SUBJECT: Application to amend OLS, revising Tech Spec 3.1 allowing full power operation of Unit 1 for interim period until appropriate safety valve ring settings can be implemented.

Subject: Oconee Nuclear Station
Docket Nos. 50-269, -270, -287

Duke Power Company
Oconee Nuclear Station
Proposed Facility Operating License Amendment

FIGURE 1

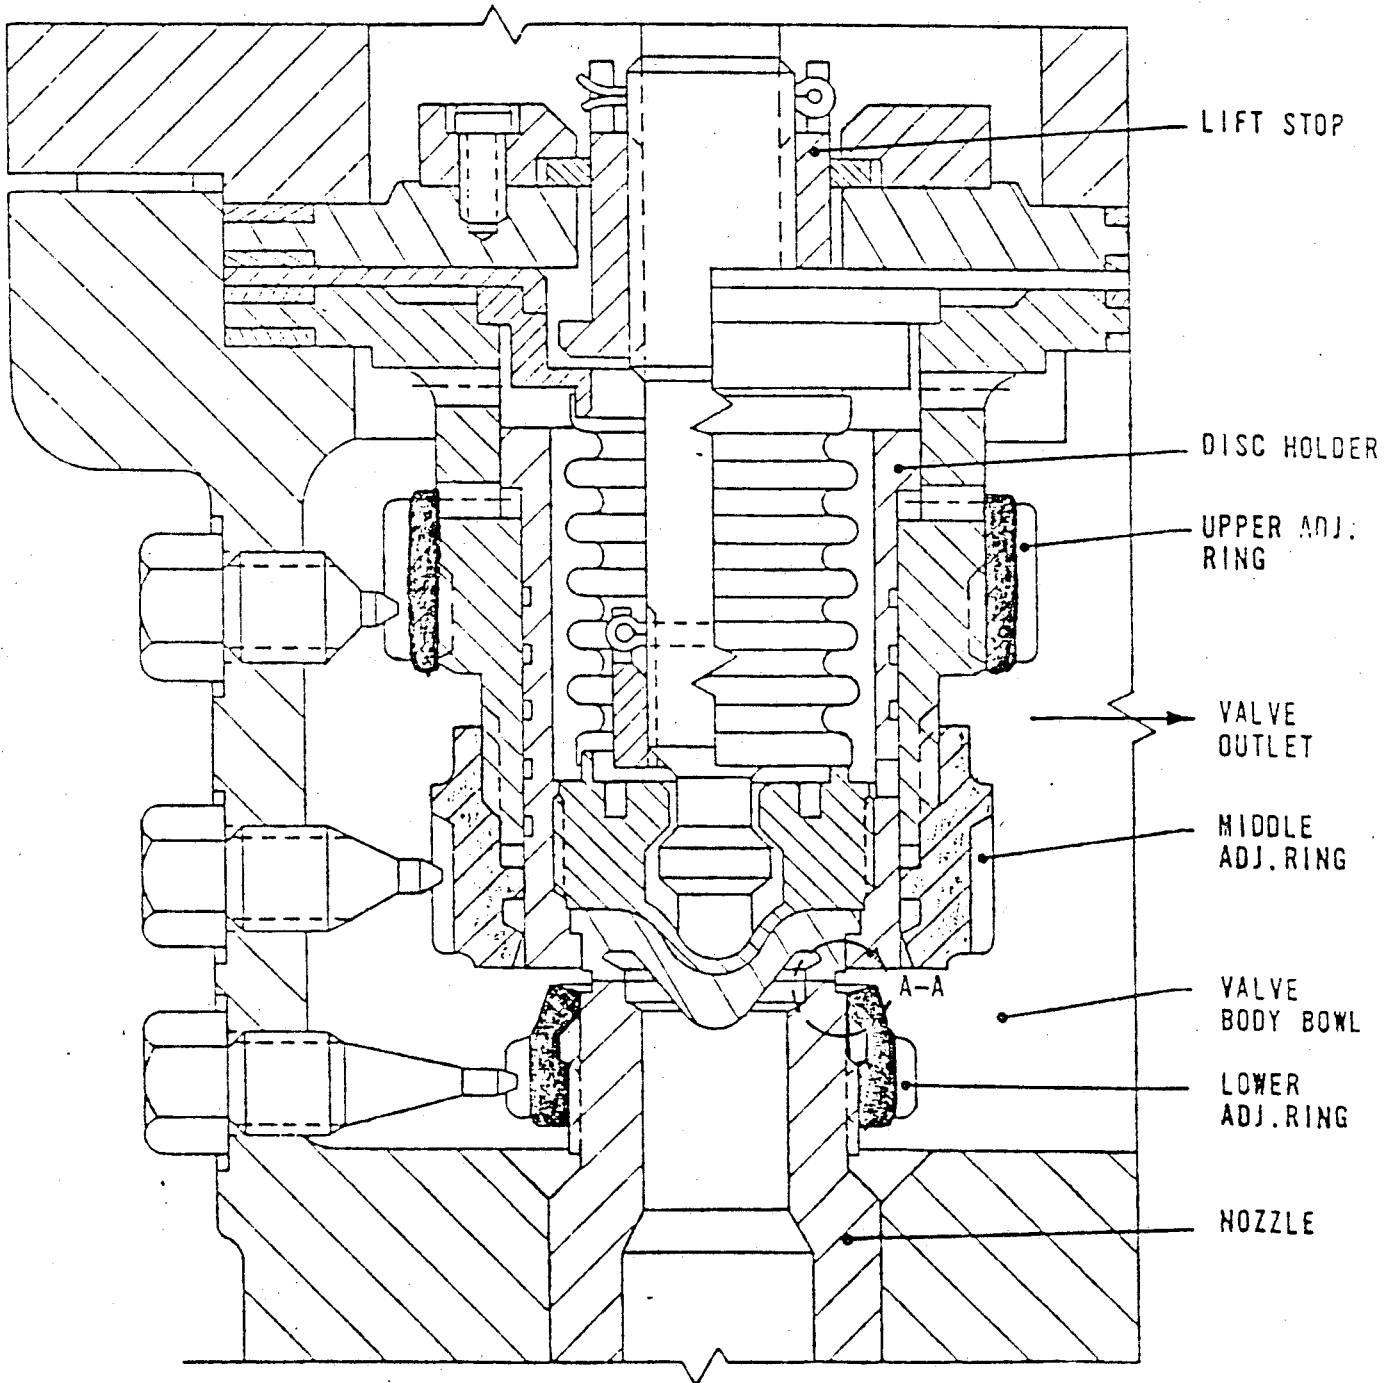
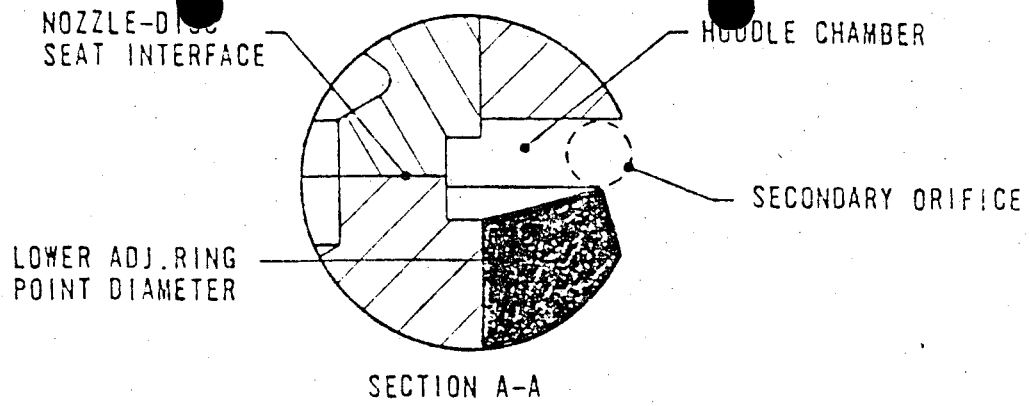
During the course of the EPRI valve testing it was determined that the positions of the rings (eg upper, middle, lower on Figure) were important to valve performance. Complete test results are contained in the "EPRI Safety and Relief Valve Report," NP2628-LD, September, 1982, which was transmitted to the NRC by David P. Hoffman on September 30, 1982. Preliminary assessment of preliminary test reports were provided in Duke letter dated July 1, 1982.

The results of the testing indicated that acceptable valve performance under all expected conditions would occur with ring settings of +11, -40, -48 (lower, middle, upper rings) for the Dresser 31739A valve.
